UNITED STATES
DEPARTMENT OF THE INTERIOR
BUREAU OF LAND MANAGEMENT
SUNDRY NOTICES AND REPORTS ON WELLS

1a. Type of Well ☒ Oil Well ☐ Gas Well ☐ Other	5. Lease Serial No NM-0405444-A
2. Name of Operator DEVON ENERGY PRODUCTION COMPANY, LP	6. If Indian, Allottee or Tribe Name
3. Address and Telephone No. 20 N. Broadway, Oklahoma City, Ok 73102-8260 405-235-3611	7. Unit or CA Agreement Name and No
4. Location of Well (Report location clearly and in accordance with Federal requirements)* 690' FNL 402' FWL D SEC 23 T23S R31E	8. Well Name and No. Todd 23D Federal 19
	9. API Well No. 30-015-36861
	10. Field and Pool, or Exploratory Ingle Wells; Delaware
	11. County or Parish State Eddy NM

TYPE OF SUBMISSION	TYPE OF ACTION
☒ Notice of Intent	☐ Acidize
☐ Subsequent Report	☐ Alter Casing
☐ Final Abandonment Notice	☐ Deepen
	☐ Fracture Treat
	☐ Casing Repair
	☐ New Construction
	☐ Change Plans
	☐ Plug and Abandon
	☐ Convert to Injection
	☐ Plug Back
	☐ Production (Start/Resume)
	☐ Reclamation
	☐ Recomplete
	☐ Temporarily Abandon
	☐ Water Disposal
	☐ Water Shut-Off
	☐ Well Integrity
	☒ Other <u>Rig Layout Change</u>

PATTERSON RIG 41

13-5/8" 3K Annular

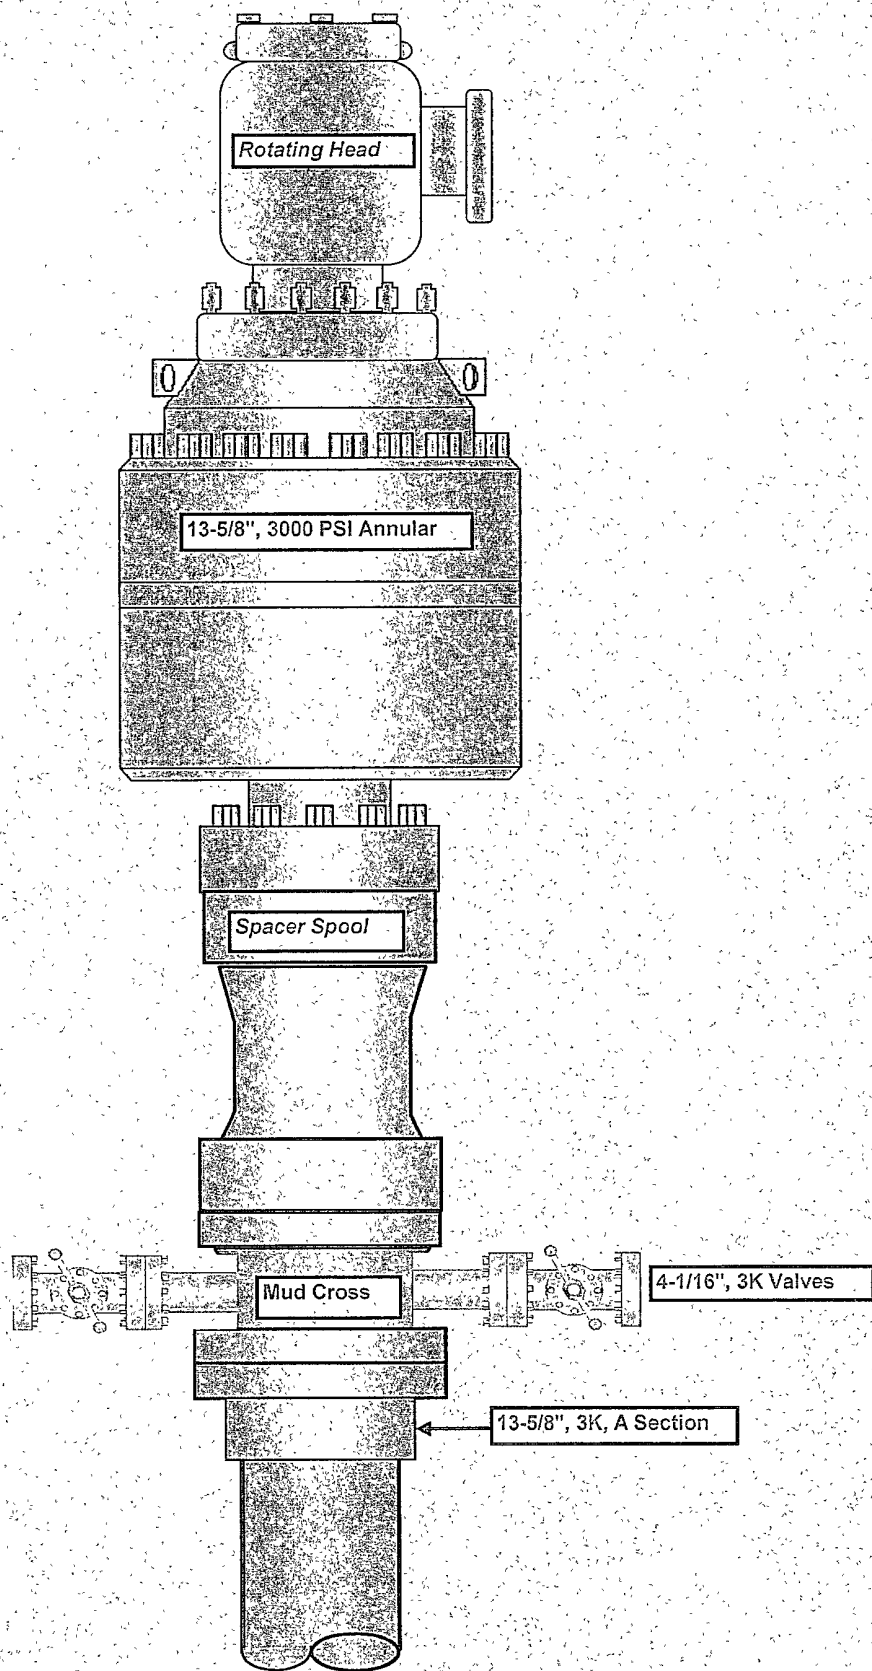
Devon Energy Production Company L. P. respectfully requests permission to change the Rig Layout from Basic Energy Services to Patterson 41. ~~The 13 5/8" 3K Annular nipples up on the surface casing to drill the intermediate hole. Request variance to pressure test with rig pump prior to drilling intermediate hole. The 11" 5K Annular and double rams (pipe & blind) nipples up on the intermediate casing to drill the production hole.~~

Phone call with Mark Cooper - Devon, items not necessary will use 0.0.11 - 70% on surface casing. Mark 11/25/09
